Submission Title: [Resolutions to comments discussed at Taipei meeting]

Re: [In response to IEEE P802.15-08-0020-03-003c-df0-comments]

Resolutions to Comments Discussed at Taipei Meeting

Comment Number #20 (6/10)

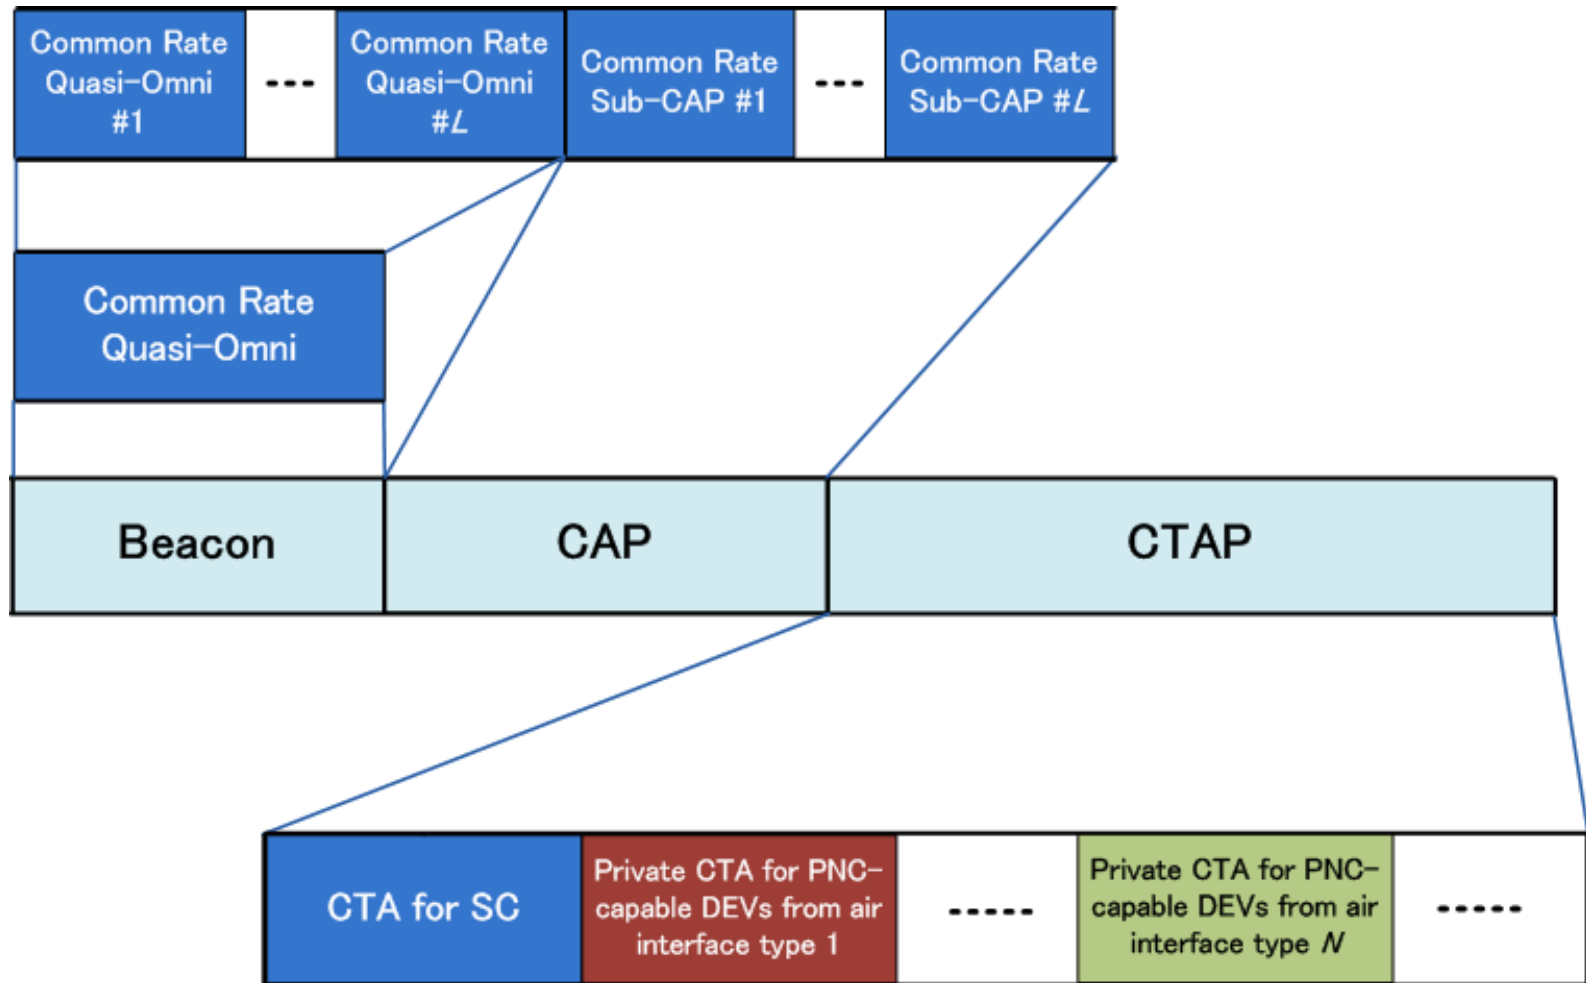
Comment: Add a requirement that MMC-PNCs implement the Common Mode

- Common Rate shall be mandatory for Super-PNC
- Common Rate is mandatory for SC DEVs and optional for OFDM DEVs
- A non-SC PNC-capable DEV **has to support Common Rate** if it wishes to communicate with Super-PNC

Comment #5

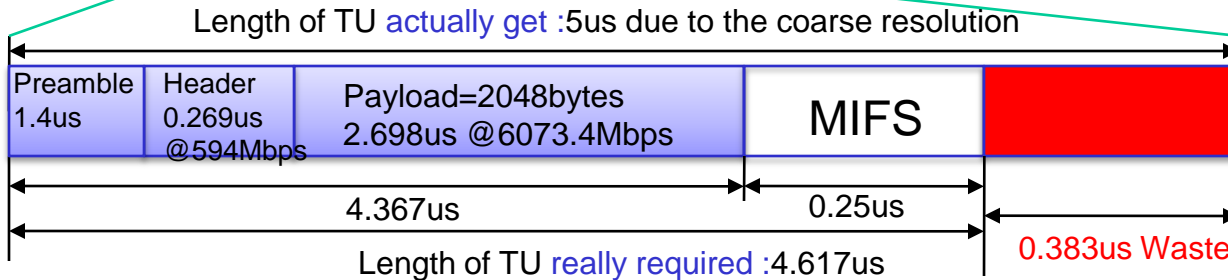
- Comment
 - Do we need reserved stream indices for beamforming and channel probing.
- Resolution
 - The resolution will be discussed at Orlando meeting

Throughput improvement from fine resolution (2/7)

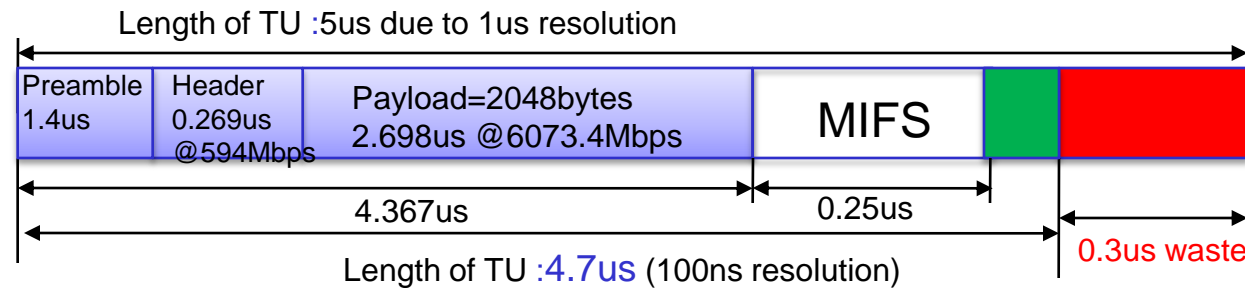
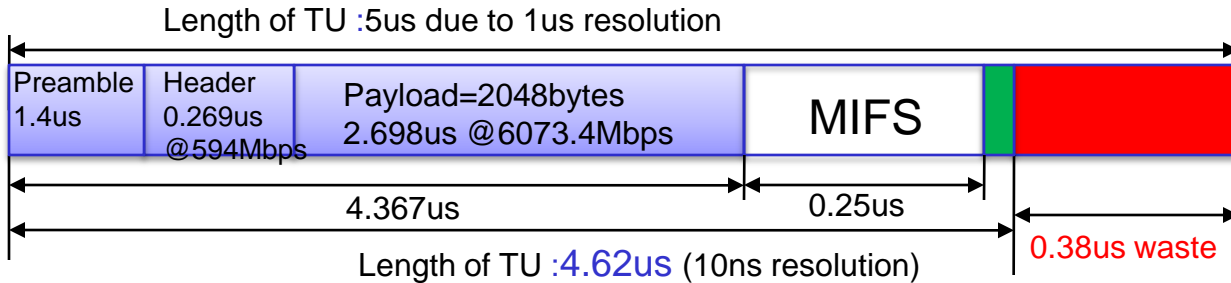
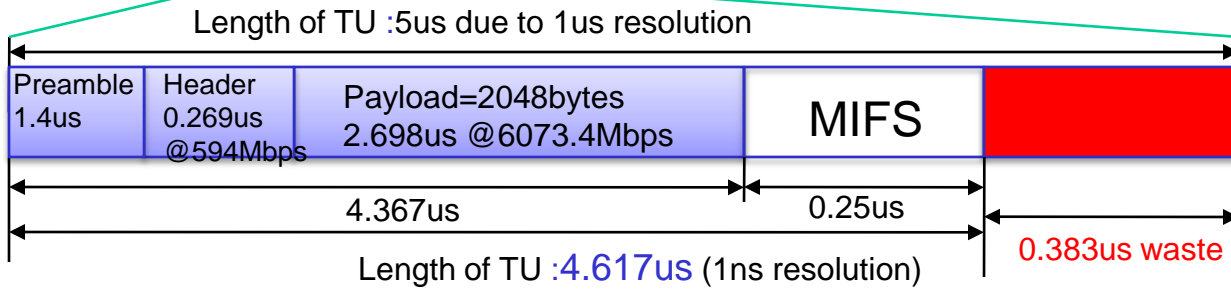
- Comment
 - Does the resolution of the superframe timing need to be less than $1\ \mu\text{s}$?”
- Resolution
 - Yes. 1 us superframe resolution should be changed to 10 ns for the sake of up to 14 % throughput improvement with 2 Kbytes data transmission at 6Gbps PHY-SAP
 - The corresponding overhead in beacon is less than 1% against superframe length, which is ignorable

- Assuming 2Kbytes data frame transmission at 6Gbps, 7% of time for per frame transmission is wasted due to coarse resolution (1us)
- 14.2% throughput improvement can be achieved if resolution is changed to 1ns

Comment # 11

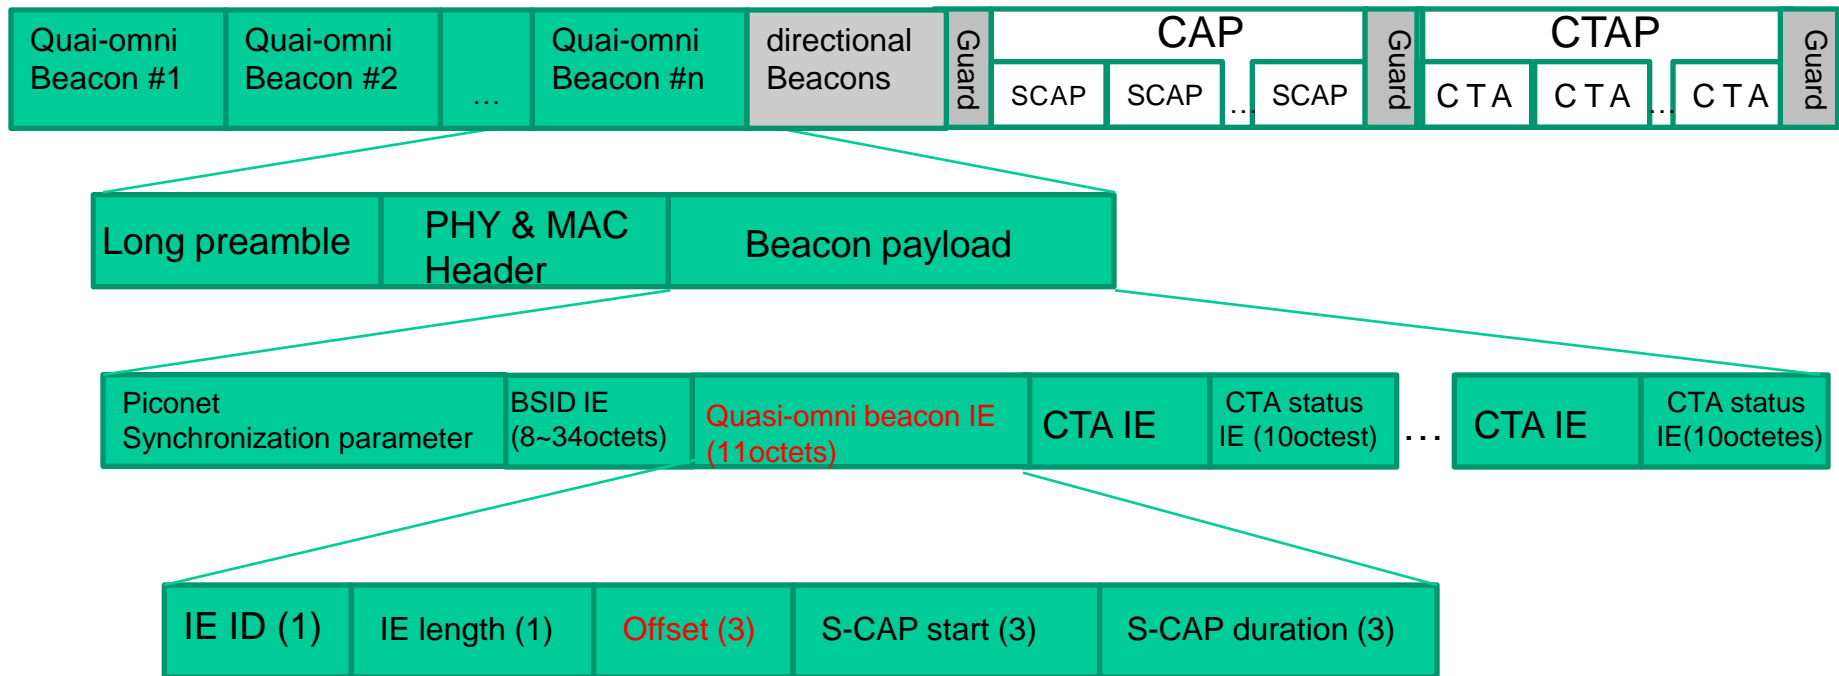
- Comment
 - How do DEVs know when the superframe starts and when the last beacon ends if they receive one beacon in the middle of a set of beacons.
- Resolution
 - Quasi-omni beacon IE is defined to indicate the offset from the start of the superframe to the first symbol of the current received beacon

Use 802.15.3 probe command for UEP information exchange

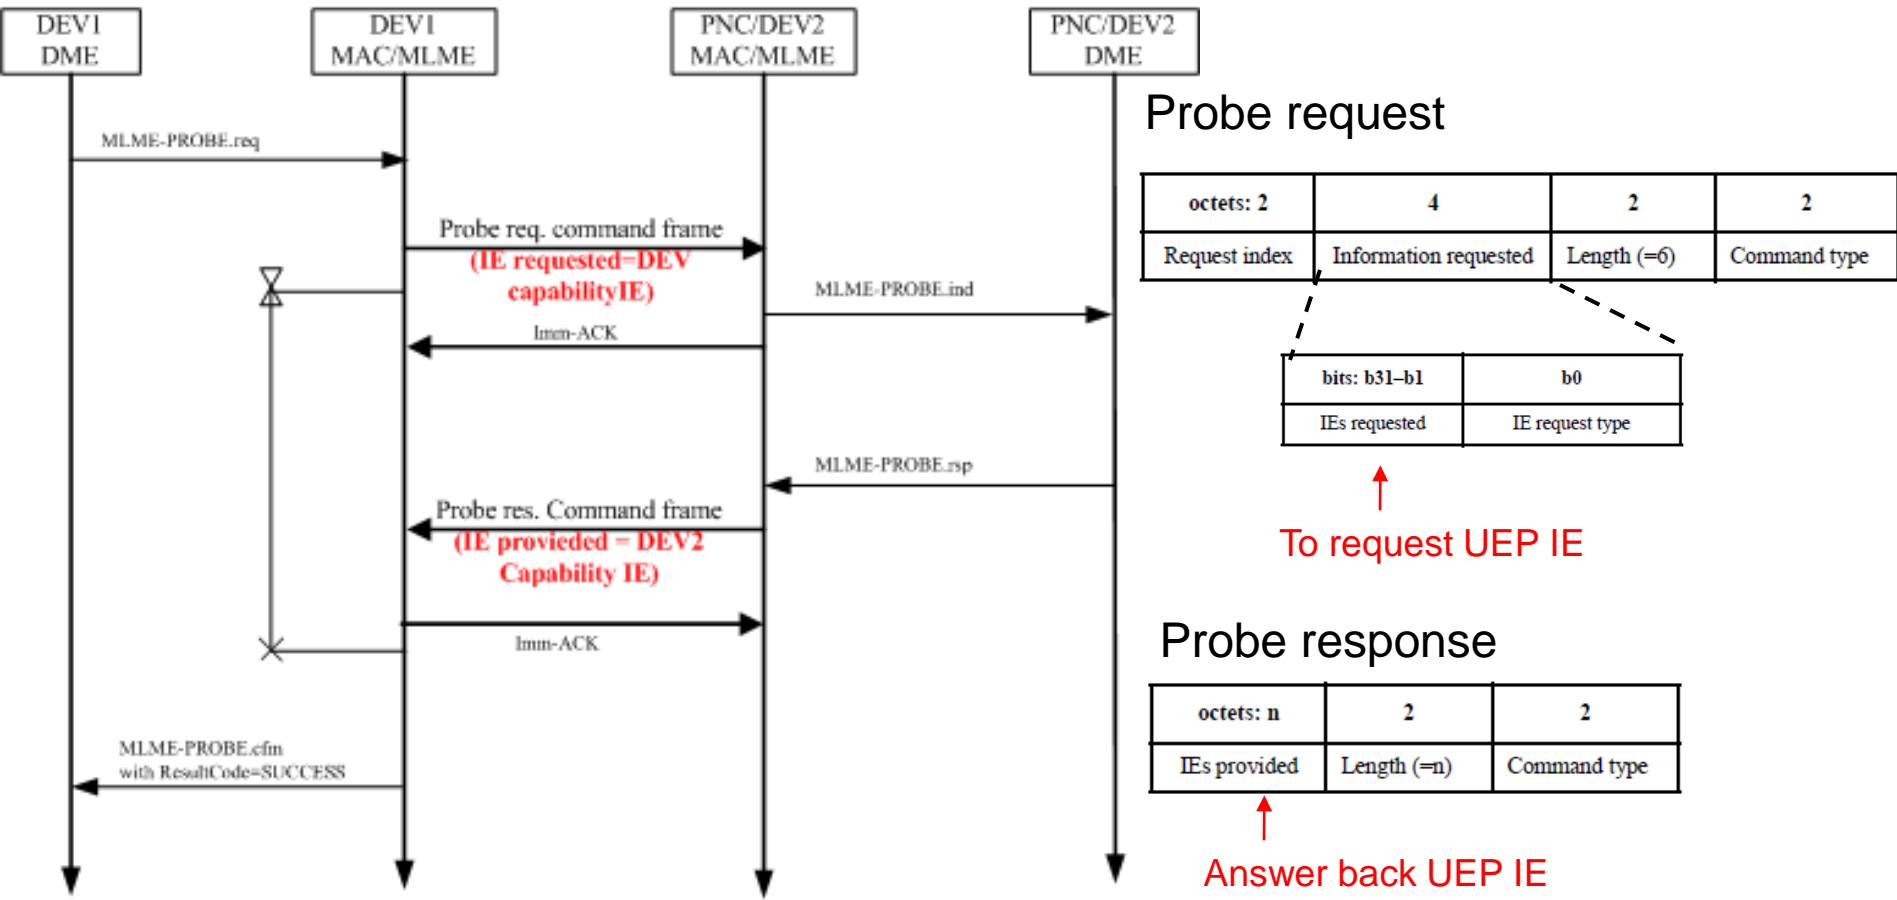
- **Comment #36**
 - Rather than using commands, if the UEP capabilities are exchanged as part of the normal capabilities exchange, then the commands are not needed.

- **Resolution**
 - That is right. 802.15.3 already has the peer discovery function (use probe command) which can be used to exchange UEP information. What needed is just to exchange UEP (TBD) IE between DEVs which have intention of UEP streaming
